NL-20-0550

Joseph M. Farley Nuclear Plant – Units 1 and 2
License Amendment Request to Revise Measurement Units Associated with Reactor Trip
System Nuclear Instrument Comparison Surveillance and Trip Setpoint for Control Room
Air Intake Radiation Monitors
SNC Responses to NRC Requests for Additional Information

**Joseph M. Farley Nuclear Plant – Units 1 and 2
License Amendment Request to Revise Measurement Units Associated with Reactor Trip
System Nuclear Instrument Comparison Surveillance and Trip Setpoint for Control Room
Air Intake Radiation Monitors
SNC Responses to NRC Requests for Additional Information**

Plant: Farley	Unit: 1&2	Calculation Number: SM-SNC972214-001	Sheet: 19
---------------	-----------	--------------------------------------	-----------

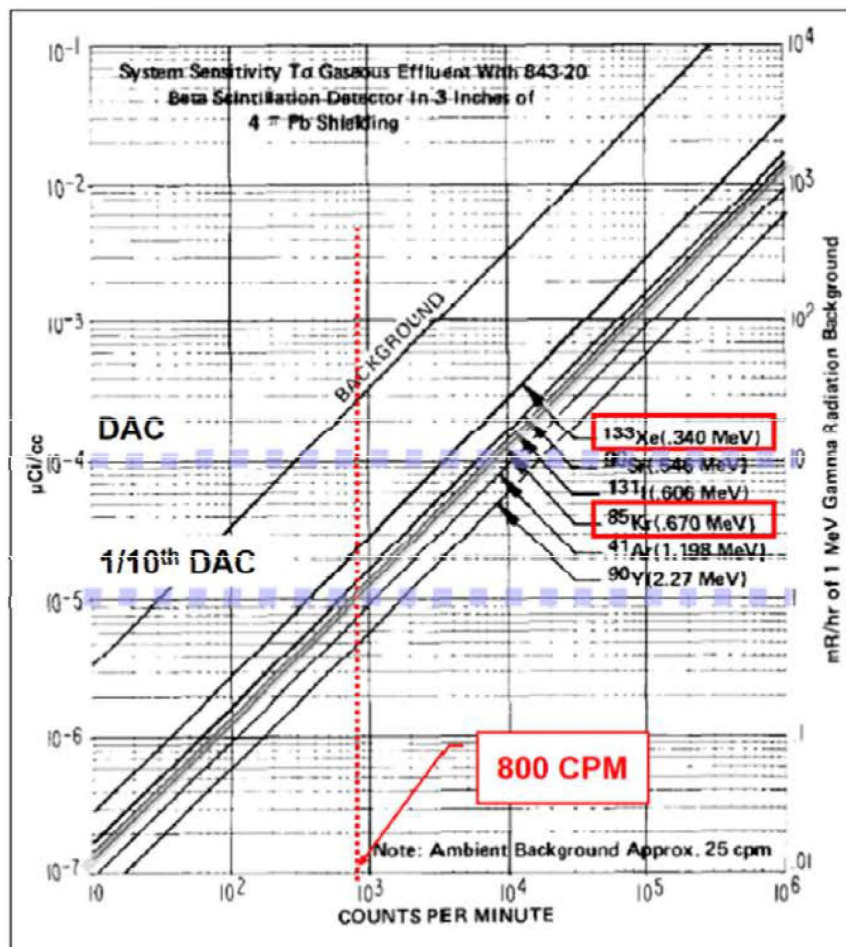
As part of the Audit, the NRC staff reviewed Farley calculation SM-SNC972214-001 to confirm the proposed change from " ≤ 800 cpm" is equivalent to " $\leq 1 \times 10^{-5}$ $\mu\text{Ci}/\text{cc}$." Please submit, on the docket, the information contained on Sheets 19 and 20 under "Basis Determination" in the section titled "R-35A/B (MCR Isolation) Setpoint." Please include the diagram on Sheet 19.

The basis for the current R-35A/B may be determined using two methods. The first method is to plot the setpoint (800 CPM; Design Input #3) on the detector gaseous effluent sensitivity curve from its operations & maintenance manual (U262532; page 72 of PDF), note where it intersects the Kr-85 line, and compare the concentration to the DAC (1.0E-04 $\mu\text{Ci}/\text{mL}$; Design Input #1) for Kr-85.

The 800 CPM setpoint line intersects the Kr-85 sensitivity line at $1.0E-05 \mu\text{Ci/mL}$, or one-tenth of its DAC. This is reasonable: MCR ventilation intake is isolated well below the regulatory limit.

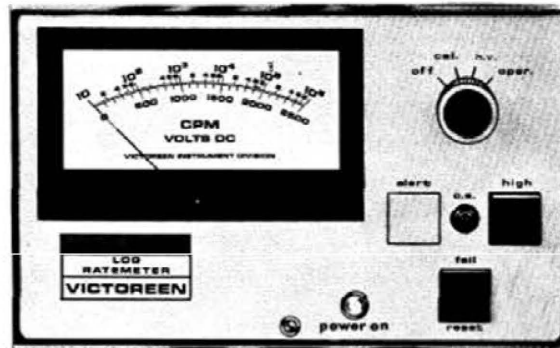
The Unit 1 R-24A/B and R-25A/B ratemeter analog display in its operations & maintenance manual U258400 (page 48 of PDF) is shown to the right. The U1 R-35A/B ratemeter is the same (page 47 of U262532), but this is a better picture.

The setpoint was likely rounded off to 800 CPM for the following reasons:

- The analog logarithmic scale display has one significant figure of accuracy. It is unlikely a setpoint with two significant figures of accuracy would have been chosen.
- It would have been very difficult to read 780 CPM on this logarithmic scale.
